Subject: SAS-2: Making 07-193 into an Annex

This is the re-creation of 07-193r1 putting it into a form that can be placed into the SAS-2 standard as an informative annex.

Figure A.1 — S-parameter model of the reference transmitter test load

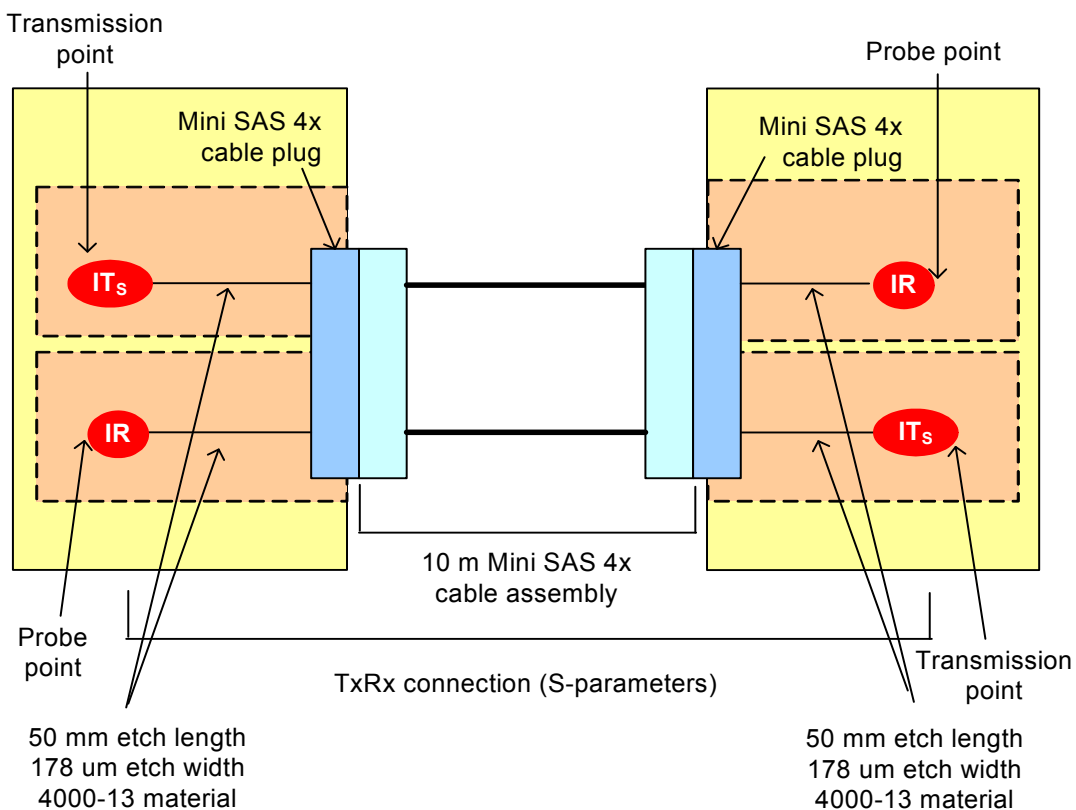
- a) an etch length of 50 mm with an etch width of 178 μm between the IT_s (see 5.3.6.5.4) and the Mini SAS 4x cable plug (see figure A.1) in Nelco® 4000-13 material environment;
- b) 10 m Mini SAS 4x cable assembly; and
- c) an etch length of 50 mm with an etch width of 178 μm between the IR (see 5.3.7.4.3) and the Mini SAS 4x cable plug (see figure A.1) in Nelco® 4000-13 material environment.

Figure A.2 — [S-parameter model of the reference transmitter test load setup](#)

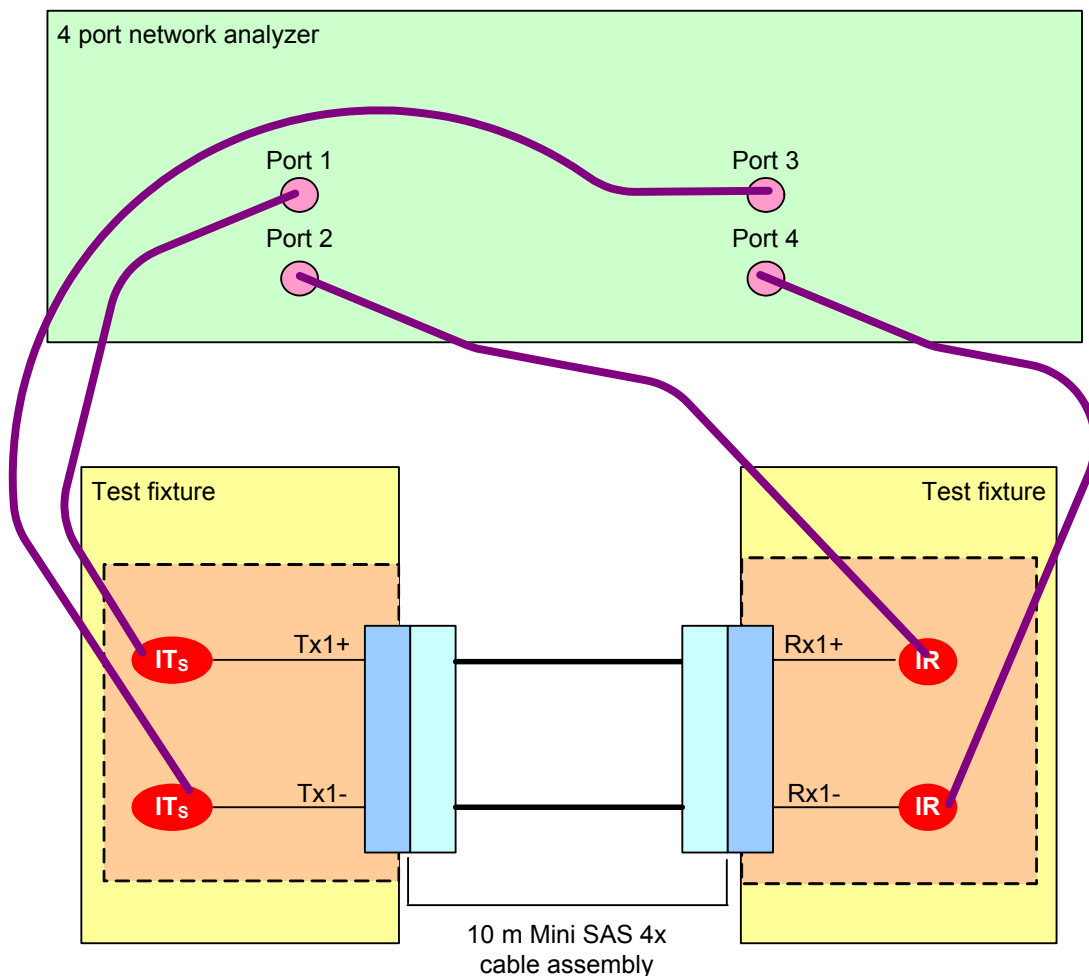
[The equipment is interconnected as shown in figure A.2.](#)

Figure A.3 — Reference transmitter test load waveform

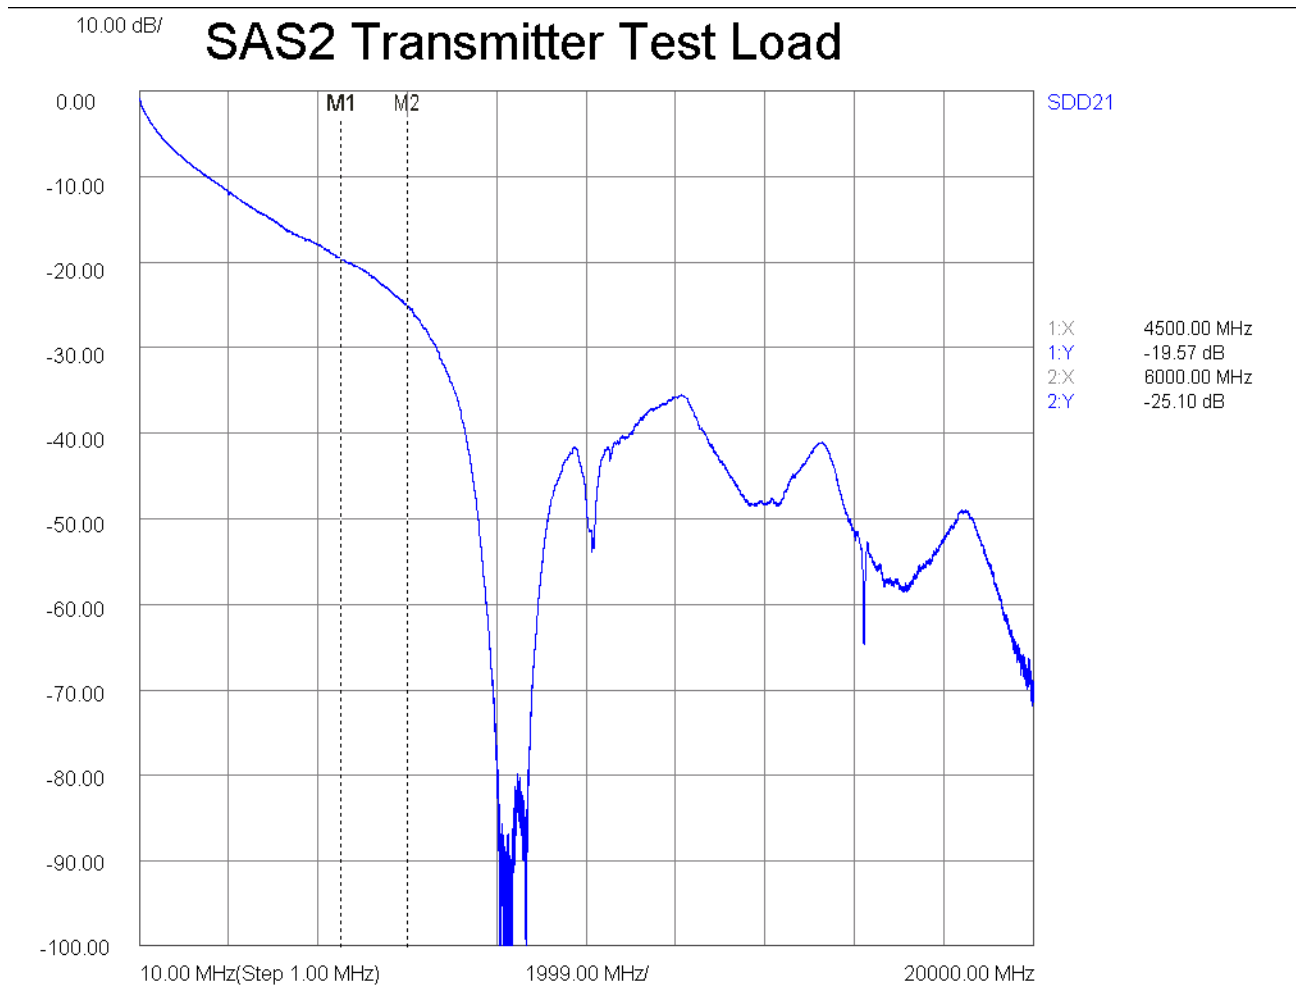
To generate the S-parameters for the reference transmitter test load sweep the 4 port network analyzer from 10 MHz to 20 GHz in 1 MHz steps. The resulting $|S_{DD21}|$ waveform should be similar to that shown in figure A.3.
